**CITY OF EAST PROVIDENCE  
WATER MAIN CLEANING AND LINING PHASE V REBID  
RFP EP23/24-26R**

**ADDENDUM # 2 – OCTOBER 9, 2024**

The following revisions, clarifications, additions and/or deletions are hereby made a part of the Bid Documents for the City of East Providence's Water Main Cleaning and Lining Phase V Rebid project, RFP EP23/24-26R.

SHEET NO. 8 OF 26

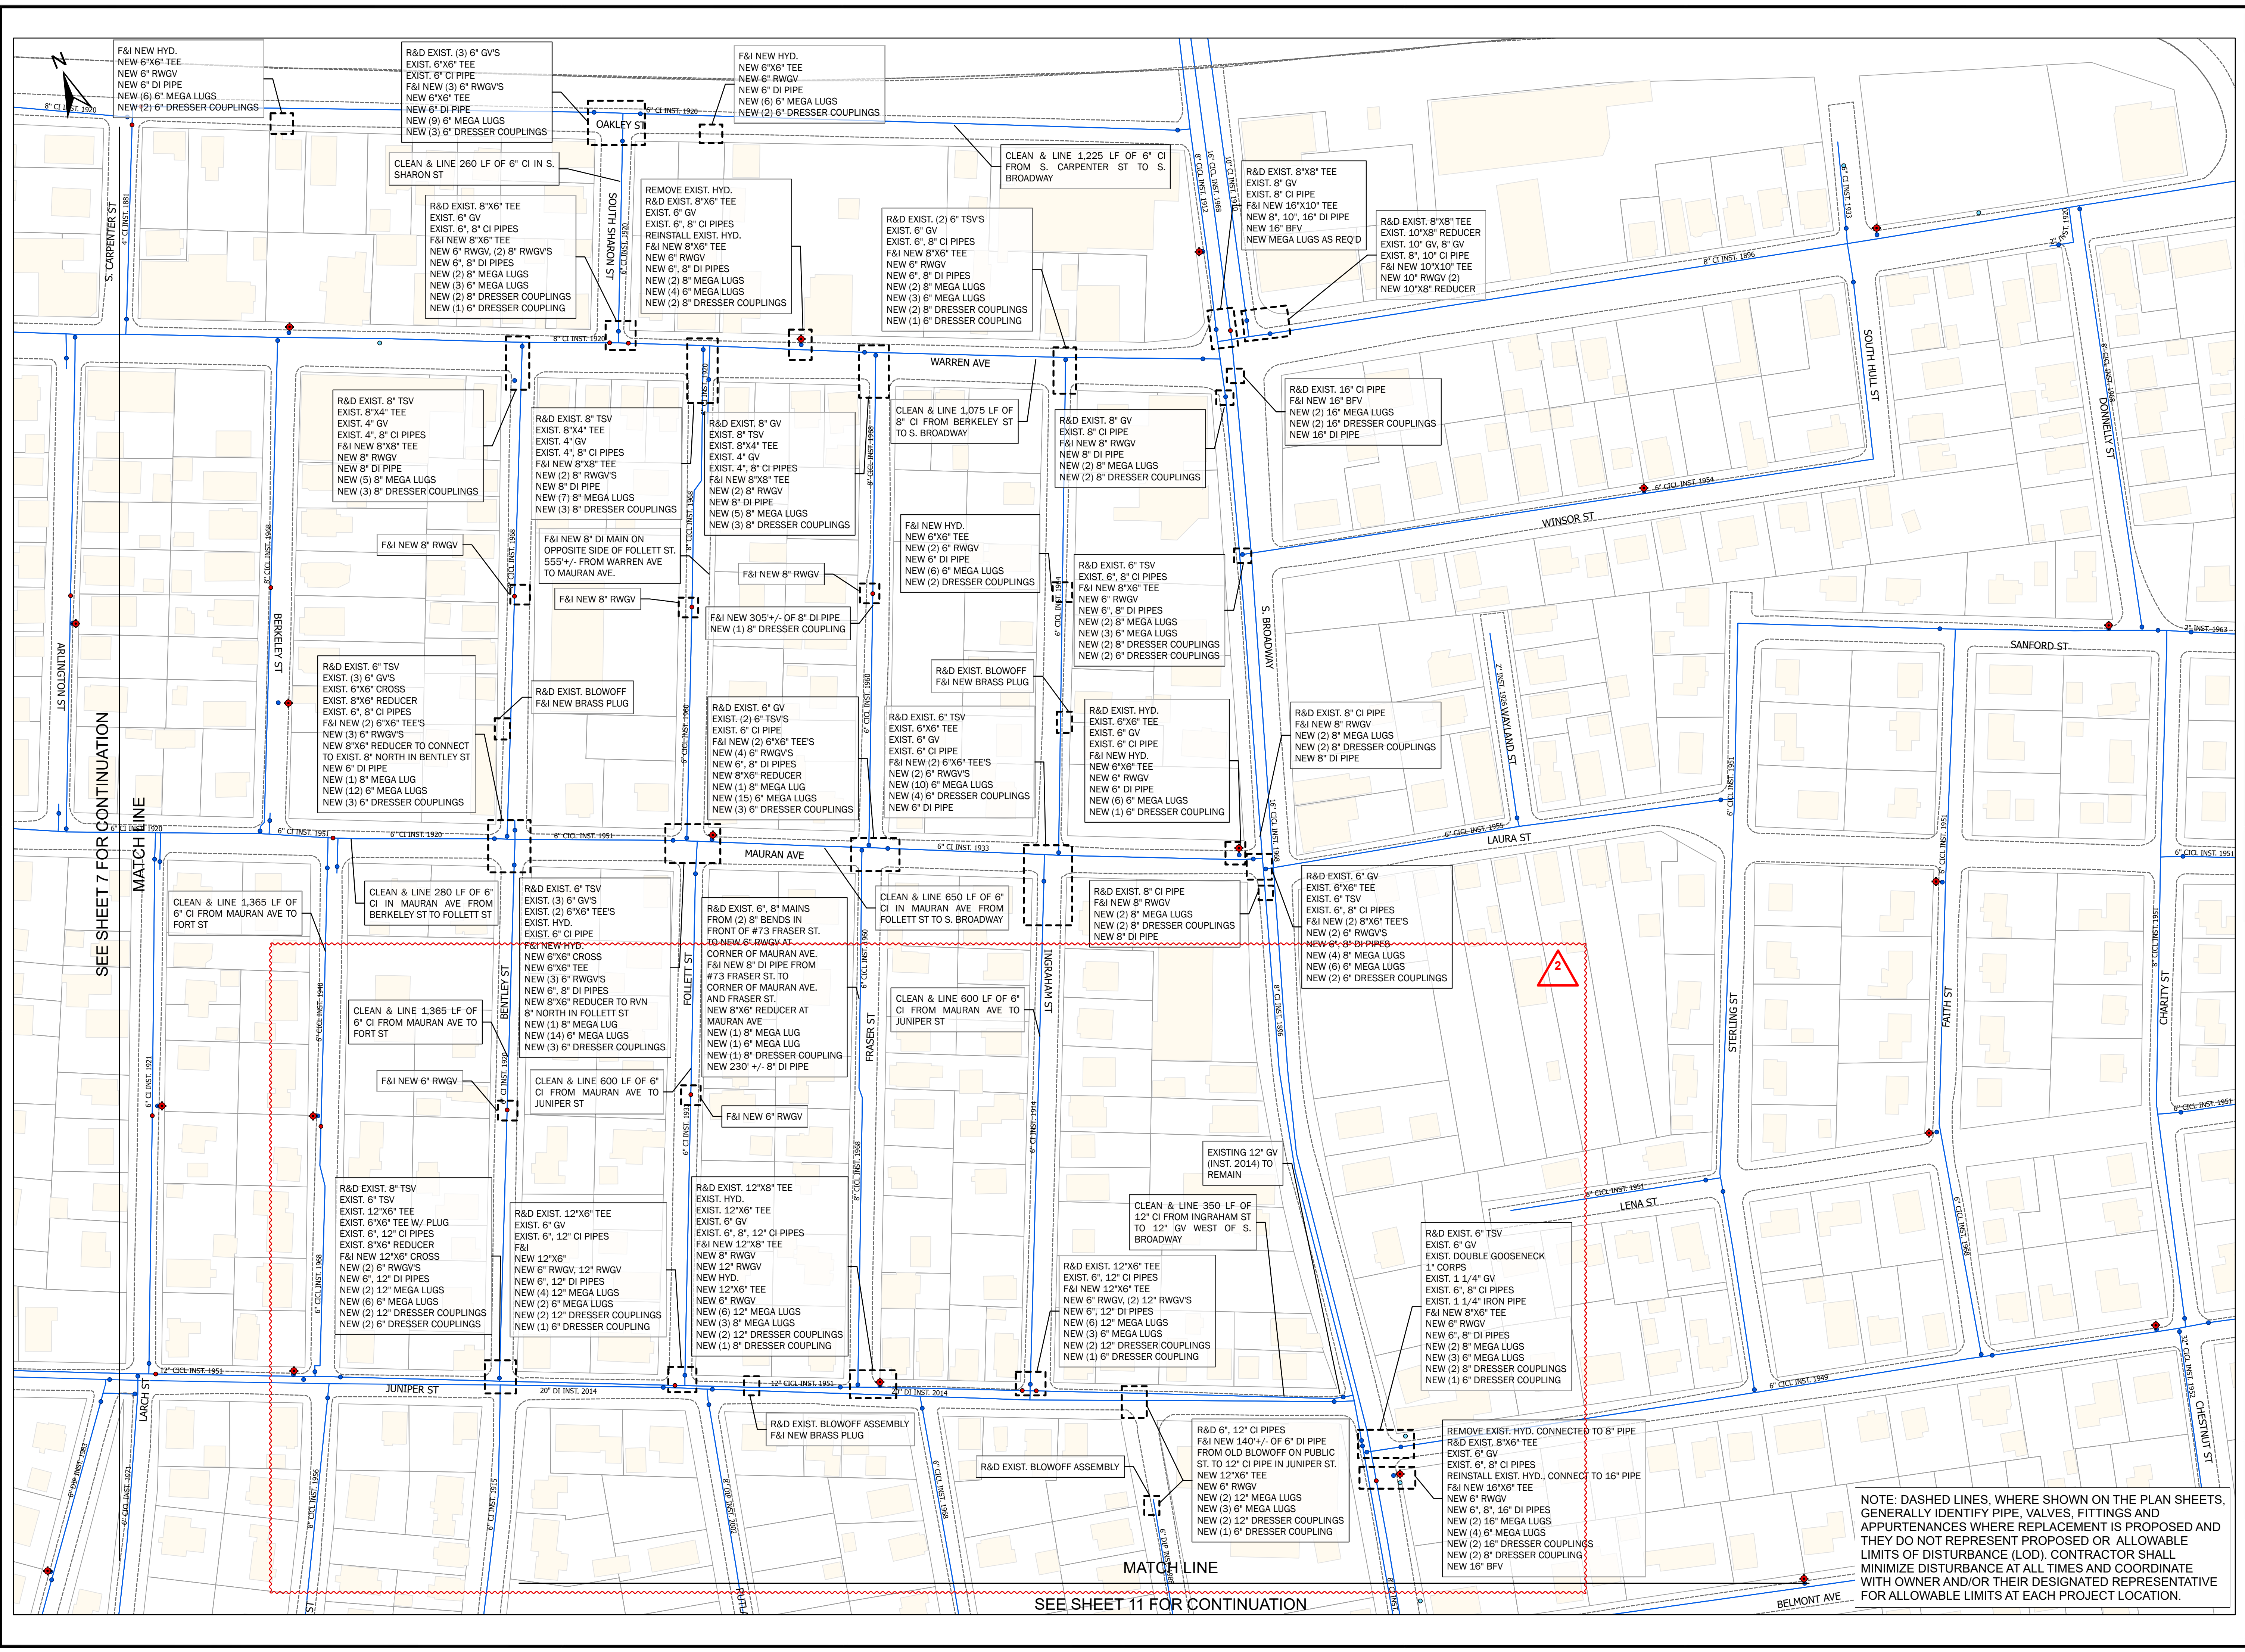
5. Sheet 8
  - a. On Juniper St., we are to abandon the 6” CIP Main. Which services need to be transferred from the 6” to 12”?
  - b. On Juniper St., between Bentley St and Follett St we c & cml 205’ of 6” CIP. It does not appear there are any notes on how this gets tied in. Also, between Follett & Ingram there are 5 12” gate valves. Is this correct? Please advise.
  - c. At the intersection of Broadway and both Oakley and Warren, no work is shown. Please let us know what needs to be done in these intersections.

**Cleaning and lining of 6” water main in Juniper Street is no longer proposed. This pipe was previously removed, and a new 20” ductile iron transmission main installed, as part of a water supply improvement project in 2014/2015. No services need to be transferred to the 12” water main. Four 12” gate valves are now proposed in Juniper Street, between Follett & Ingraham. Drawing C2.3 (Sheet 7) and C2.4 (Sheet 8) have been revised as part of Addendum No. 2 and are attached.**

**Valves at the intersections of S. Broadway with Oakley Street and S. Broadway with Warren Avenue were installed in 2012 during a previous cleaning and lining project. These valves are to remain. Contractor shall excavate a work pit in these locations as required to perform cleaning and lining of existing water main in Oakley Street and Warren Avenue.**

C2.5  
SHEET NO. 9 OF 26

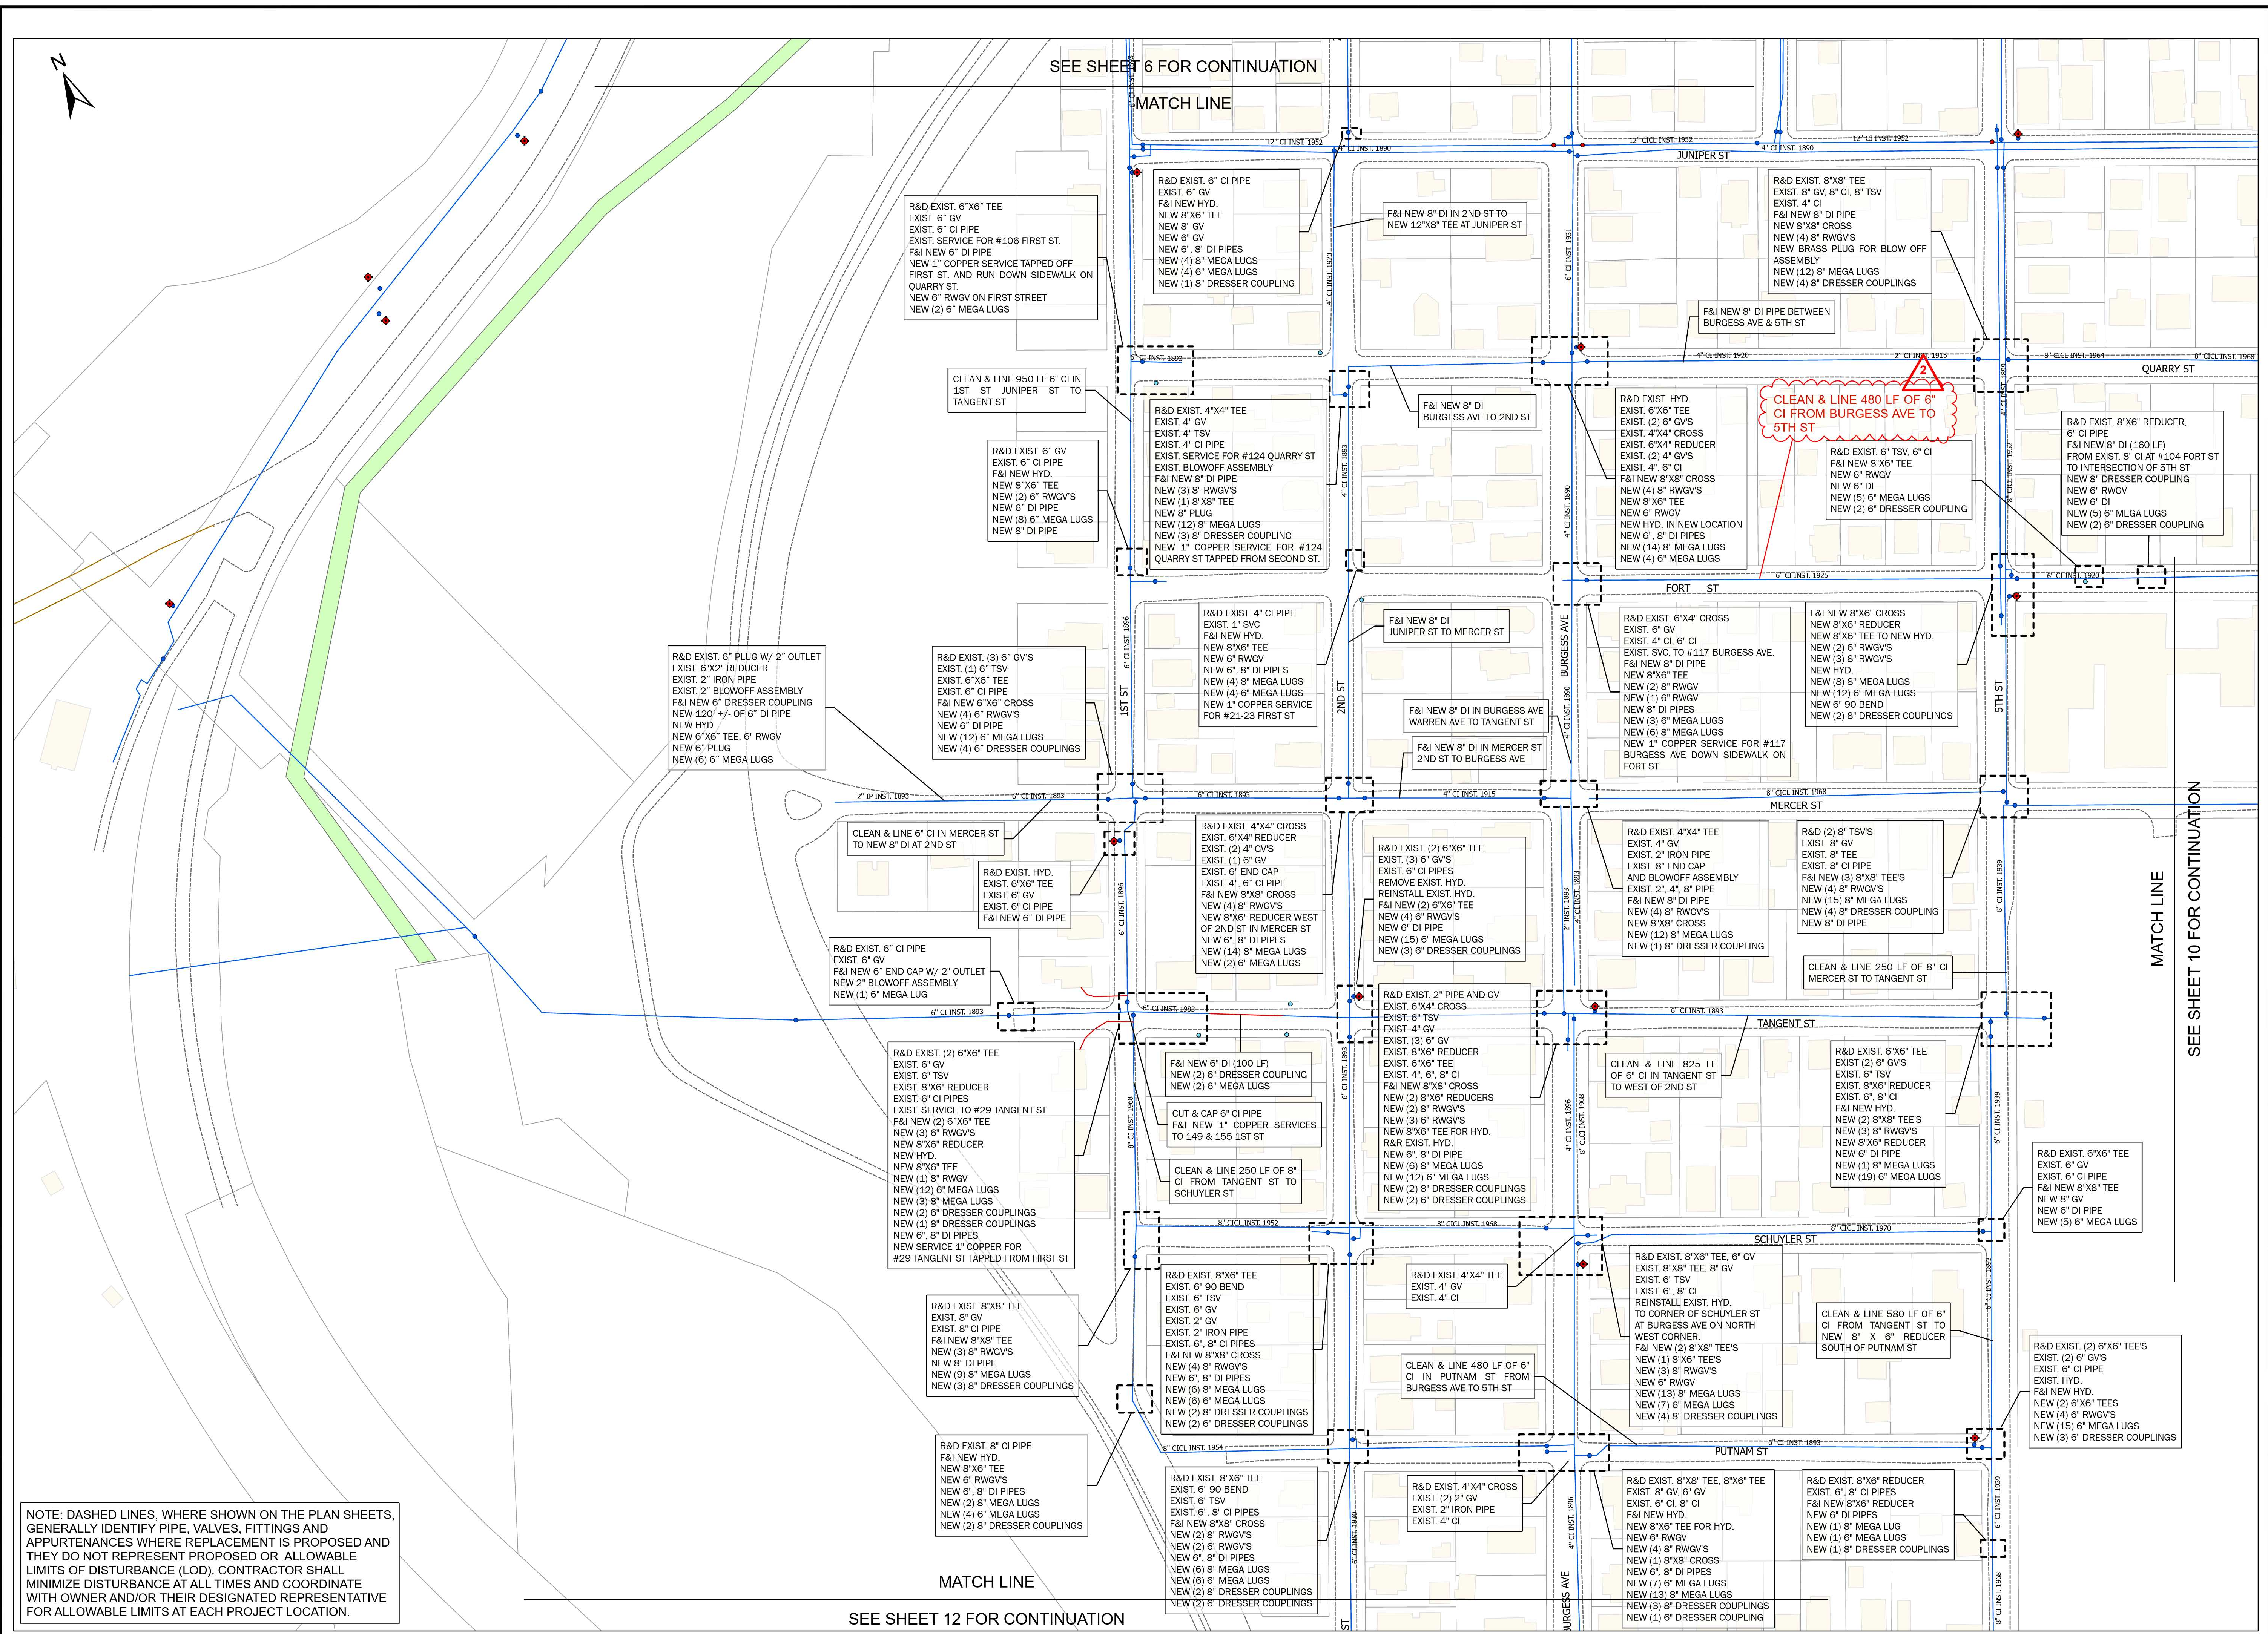
6. Sheet 9/10
  - a. Is Tangent Street west of 1<sup>st</sup> a dead end?
  - b. At Fort St. near 5<sup>th</sup> St. it states that to F&I 160’ of 8” DIP from #104 to intersection of 5<sup>th</sup> St. On Sheet 10 it says c & cml from 5<sup>th</sup> St to 7<sup>th</sup> St. Which one is it? Are there two mains?

**The 6” cast iron water main in Tangent Street continues to a closed valve approximately 100 feet west of the intersection with 1<sup>st</sup> Street where a new blowoff assembly is proposed. The water main continues west to another closed valve near Veterans Memorial Parkway.**

**Installation of approximately 160 linear feet of new 8-inch ductile iron in Fort Street, from 5<sup>th</sup> Street easterly to an existing 8”x6” reducer, is proposed. The existing 8” water main east of this reducer does not require cleaning and lining. However, cleaning and lining of an approximately 480’ section of 6” CI water main in Fort Street, between Burgess Avenue and 5<sup>th</sup> Street, has been added. These sheets have been revised accordingly. Please refer to attached Sheets C2.5 and C2.6 revised by Addendum No. 2.**
